**Application for Planning Permission for Proposed Temporary Green Fuel Station for Electric Private Vehicles with Ancillary Facilities for a Period of 3 Years at Lots 1343RP(Part), 1356RP in D.D. 78 and Adjoining Government Land, Lin Chuk Road, Ta Kwu Ling North, N.T.**

**(Application No. A/NE-TKLN/124)**

We refer to the captioned application and herewith submit our responses to the comments from Drainage Services Department and a revised Drainage Proposal for your consideration.

**Responses to Comments from Government Departments on Drainage Proposal of Planning Application No. A/NE-TKLN/124  
(refer to the submission to PlanD on 1 June 2026)**

<p style="font-weight: bold; margin: 0;">何田顧問工程師有限公司</p> <p style="font-weight: bold; margin: 0;">HO TIN &amp; ASSOCIATES</p> <p style="font-weight: bold; margin: 0;">CONSULTING ENGINEERS LIMITED</p>	
SCALE	DRAWING No.
1 : 1000 - A4	FIGURE D2

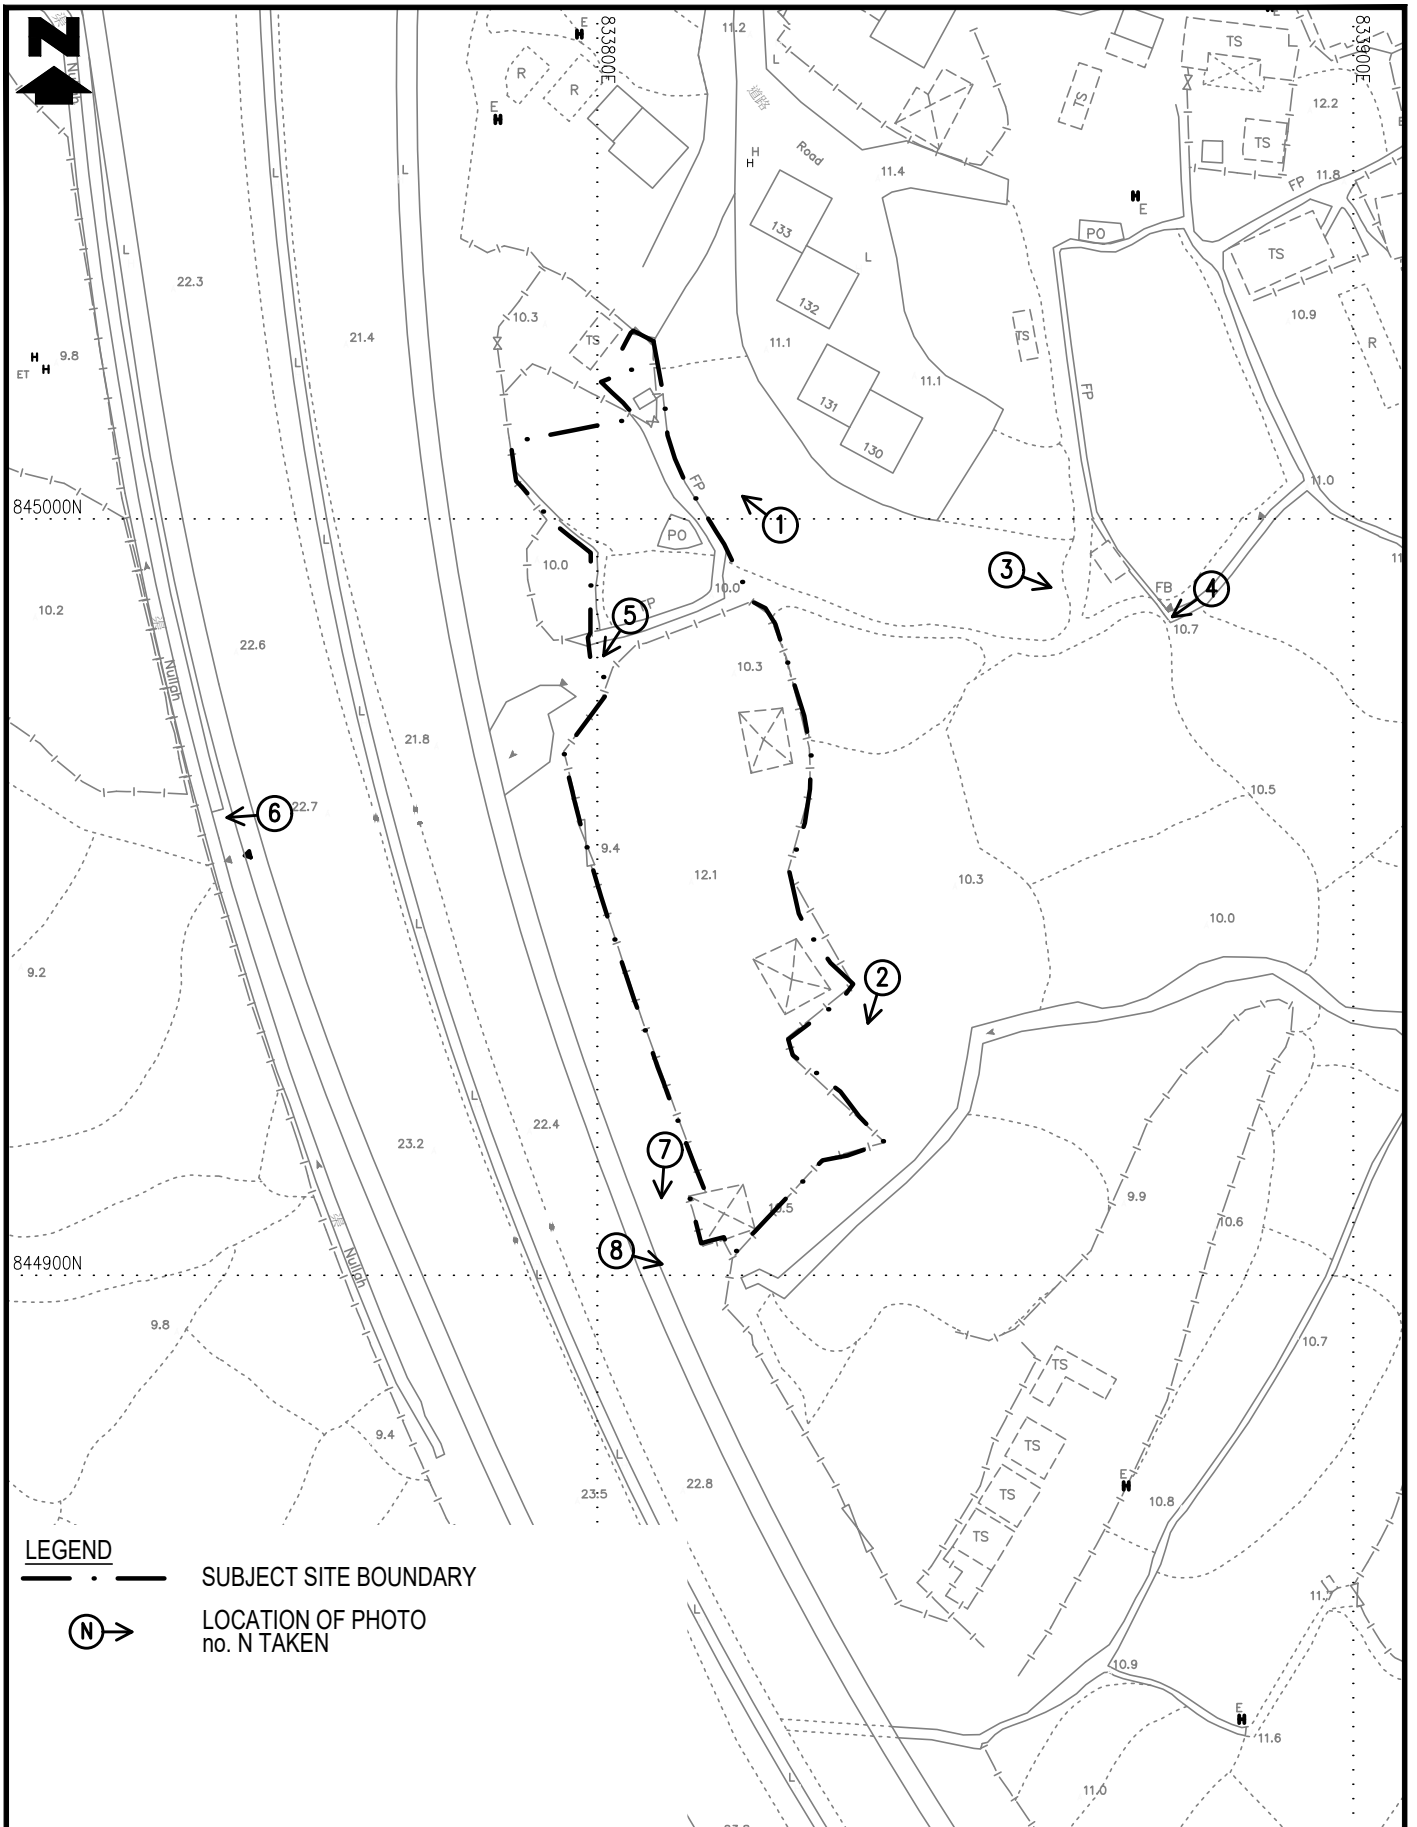
13. Drawing no. Figure D4 refers:	
(a) the applicant should indicate the proposed site formation levels/ground levels of the application site if no site formation will be carried out;	The proposed site formation levels/ground levels of the application site are added into <b>Figure D2</b> .

<b>何田顧問工程師有限公司</b> <b>HO TIN &amp; ASSOCIATES</b> CONSULTING ENGINEERS LIMITED	
SCALE	DRAWING No.
1: 1000 - A3	FIGURE D4

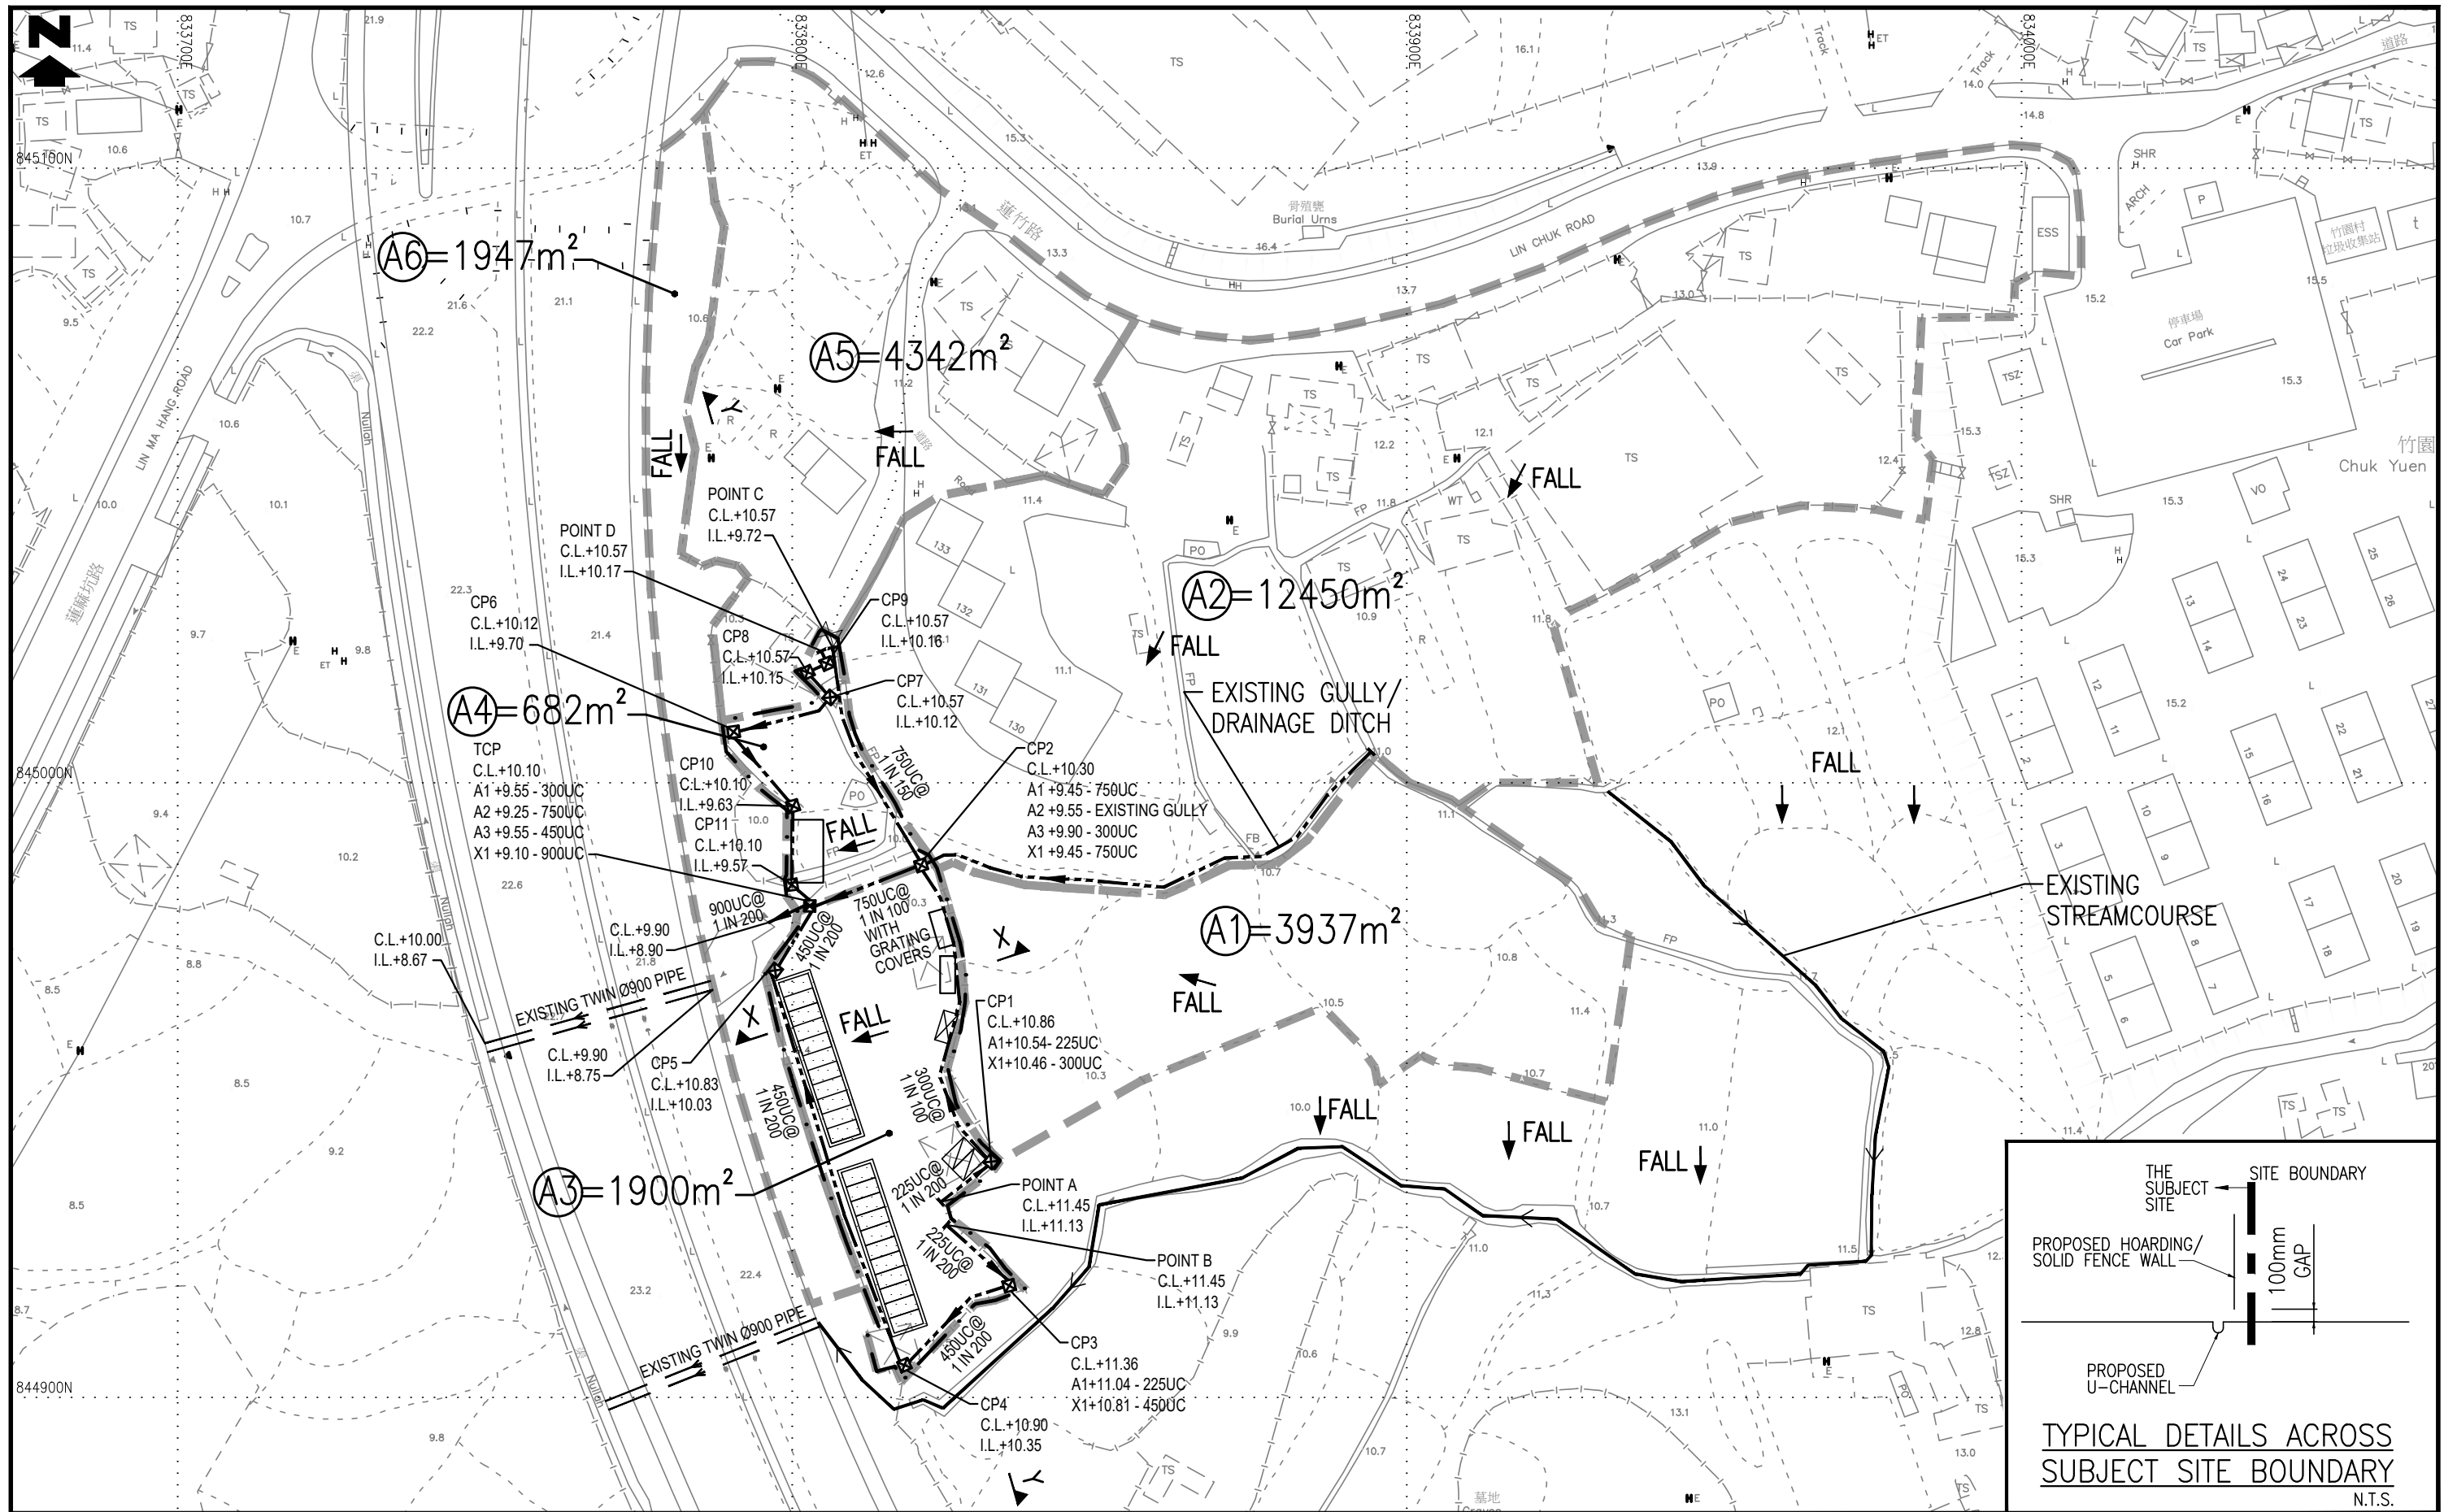
(b) catchpit should be provided at a location of a change of flow direction of the proposed u-channel (e.g. at the northern part of the application site); and	Catchpit is added at location of a change of flow direction of the proposed u-channel, in particular, at the northern part of the application site

(c) thickness of concrete cover/grating should be considered when determining the invert levels of catch pits and u-channels to ensure the depths of u-channels are adequate. For instance, the depth of 750UC is less than 750mm at CP2;	Thickness of concrete cover/grating is now considered when determining the invert levels of catch pits and u-channels to ensure the depths of u-channels are adequate.

FIGURE D5

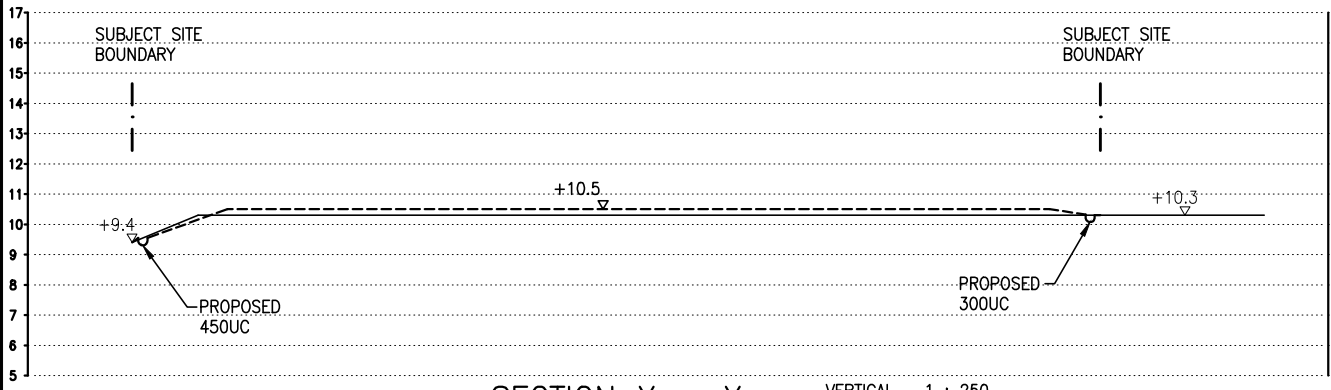
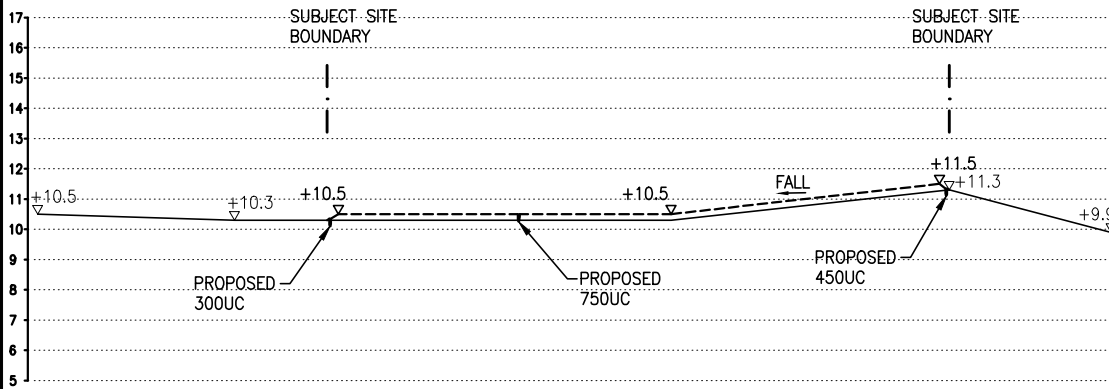
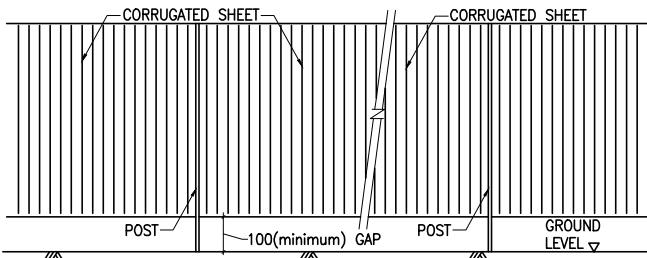
COMMENTS	RESPONSES
<p>14. the applicant should provide sectional views of the application site in two different directions showing clearly any walls would be erected or kerbs would be laid along the boundary of the application site, the proposed and existing drainage facilities, flow direction, the existing ground level of the adjacent lands and the formation level of the application site; and</p>	<p>Section 'X'-'X' and 'Y'-'Y' are shown in a new <b>Figure D5</b>.</p>
<p>15. the applicant should supplement connection details between the existing channel and the proposed drainage facilities. Invert levels of the existing channel at the connection points should be indicated in the details.</p>	<p>Connection details between the existing channel and the proposed drainage facilities are shown in <b>Figure D6</b>. Details of the proposed outfall is shown in <b>Figure D7</b>.</p>

COMMENTS	RESPONSES
4. where walls are erected or kerbs are laid along the boundary of the application site, peripheral channels should be provided on both sides of the walls or kerbs with details to be agreed by DSD;	Where solid security hoarding/fence is to be constructed, 100mm high gap will be formed at the bottom of the solid security hoarding/fence along the subject site boundary.

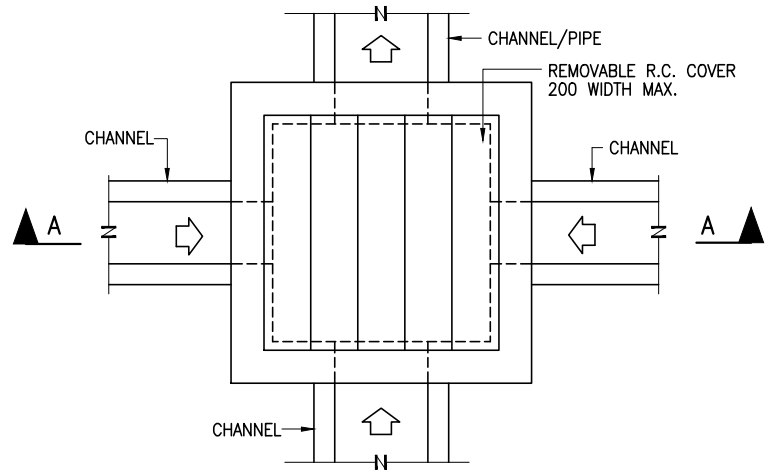
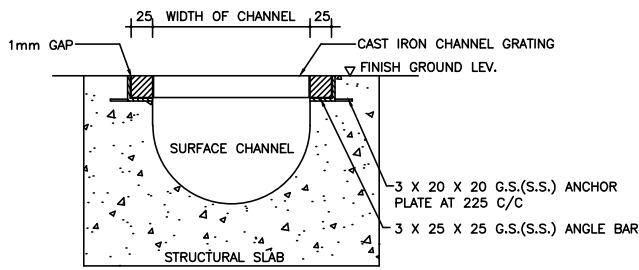
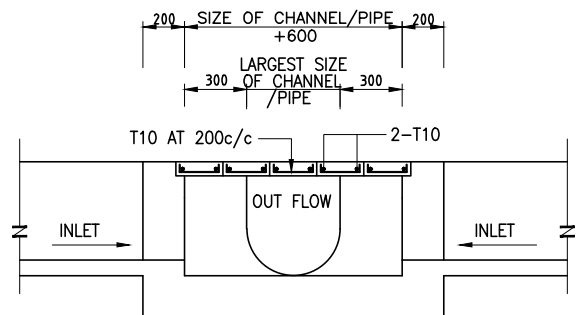
2. the cover levels of proposed u-channels and catch pits should be flush with the adjoining ground level;	Noted and amended. Corresponding details are shown in <b>Figure D8</b> .
